**Standardization of technical and safety requirements in inland navigation:
Recommendations on Harmonized Europe-Wide Technical Requirements
for Inland Navigation Vessels (Resolution No. 61, revised)**

Amendments to Resolution No. 61, revised

Note by the secretariat

A. Amendment to chapter 4, “Safety clearance, freeboard and draught marks”

Figure 4-3.7
Measurement/draught scale

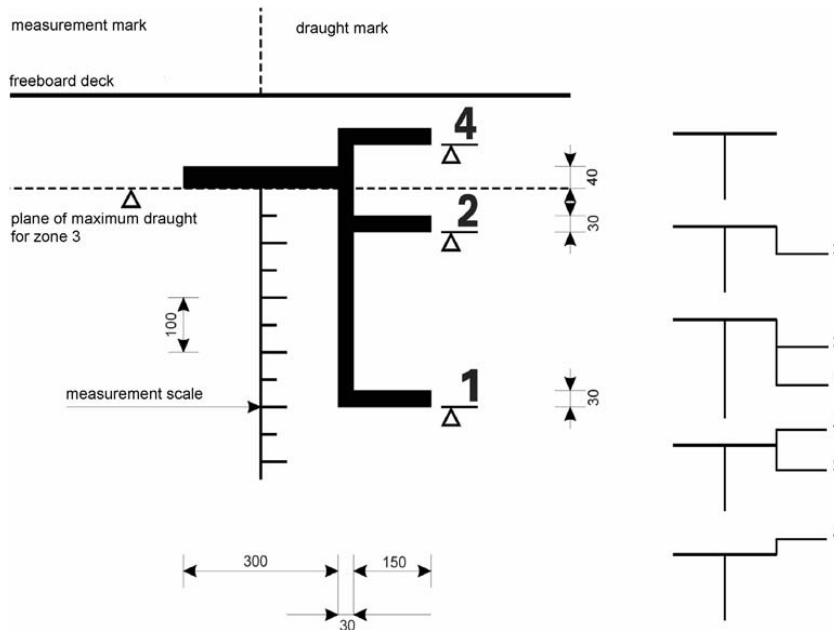
4-3.7 For vessels operating on zones of inland waterways other than Zone 3 (Zones 1, 2 or 4) the bow and stern pairs of draught marks provided for in 4.3.3 shall be supplemented by adding a vertical line to which one or, in the case of several zones,

several additional draught lines 150 mm long shall be affixed towards the bow, in relation to the draught mark for Zone 3.

This vertical line and the horizontal line shall be 30 mm thick. In addition to the draught mark towards the bow of the vessel, the relevant zone numbers shall be indicated in lettering 60 mm high × 40 mm deep (see Figure 4-3.7).

The lower edge of each freeboard draught line shall correspond to the freeboard prescribed plane of maximum authorised draught for the navigation zone concerned.

Figure 4-3.8

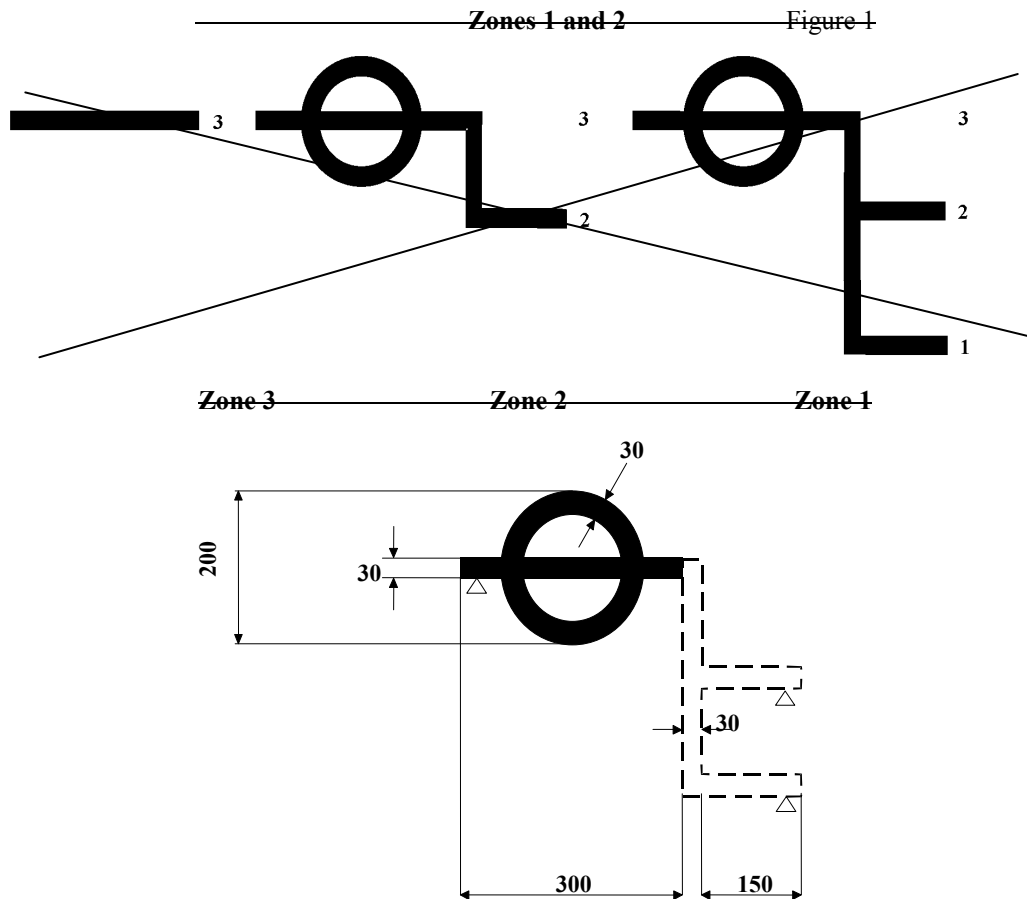
~~4.4.1.2 4-3.8~~ The freeboard mark for vessels for zone 3 consists of a horizontal band of 300 mm long and 40 mm width. The centrally located measurement/draught scale for zones 1 and 2 may be replaced by a freeboard mark.

The freeboard mark for zones 1 and 2 shall consist of a ring intersected through its centre by a horizontal line which shall be supplemented if necessary by additional freeboard lines.

The width of the ring and of all the other lines of the freeboard mark shall be 30 mm; the outer diameter of the ring shall be 200 mm; the length of the horizontal line intersecting the ring shall be 300 mm; and the size of the numerals designating the zones shall be 60 x 40 mm (Figure 4-3.8).

The centre of the ring shall be placed amidships. The lower edge of the horizontal line which intersects the ring shall pass through the centre of the ring and shall constitute the freeboard line

If the vessel is intended to navigate in several navigation zones, a vertical line and additional freeboard lines 150 mm in length shall be applied forward of the centre of the ring.

Figure 4-3.9

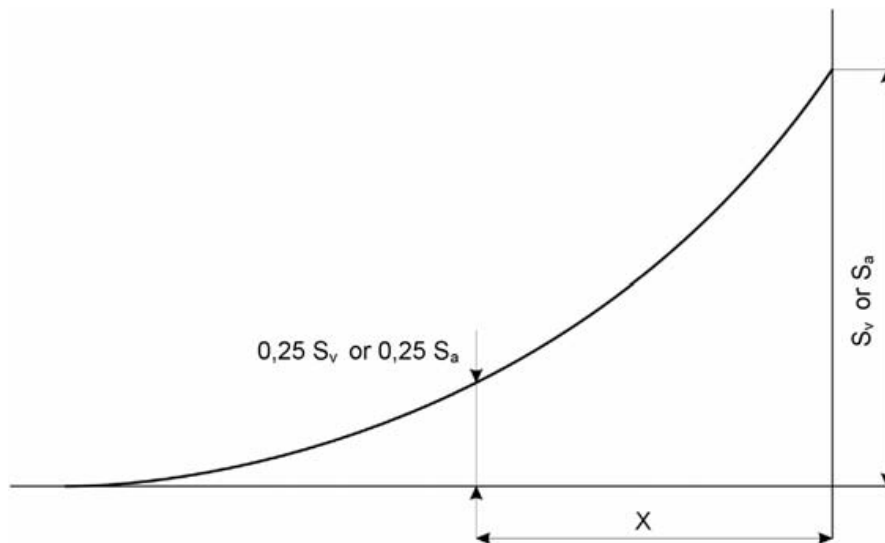
$$p = 4 \cdot \frac{x}{L}$$

x is the abscissa, measured from the extremity of the point where the sheer is $0.25 S_v$ or $0.25 S_a$ (see figure 4-3.9).

However, coefficient p will not be taken to be more than 1.

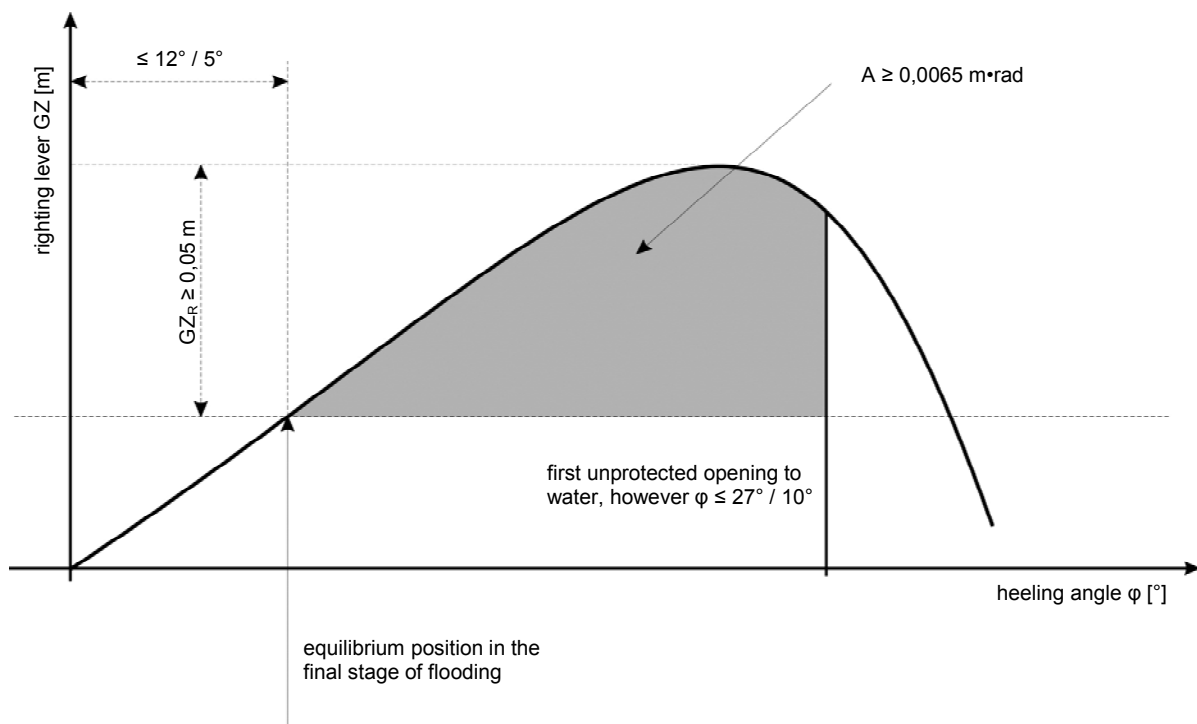
22A-4.5 For all intermediate stages of flooding referred to in paragraph 22A-4.3, the following criteria shall be met:

- (i) the heeling angle ϕ at the equilibrium position of the intermediate stage in question shall not exceed 15° (5° where containers are not secured);
- (ii) beyond the heel in the equilibrium position of the intermediate stage in question, the positive part of the righting lever curve shall display a righting lever value of $GZ \geq 0.02$ m (0.03 m where containers are not secured) before the first unprotected opening becomes immersed or a heeling angle ϕ of 27° is reached (15° where containers are not secured);

(iii) non-watertight openings shall not be immersed before the heel in the equilibrium position of the intermediate stage in question has been reached.
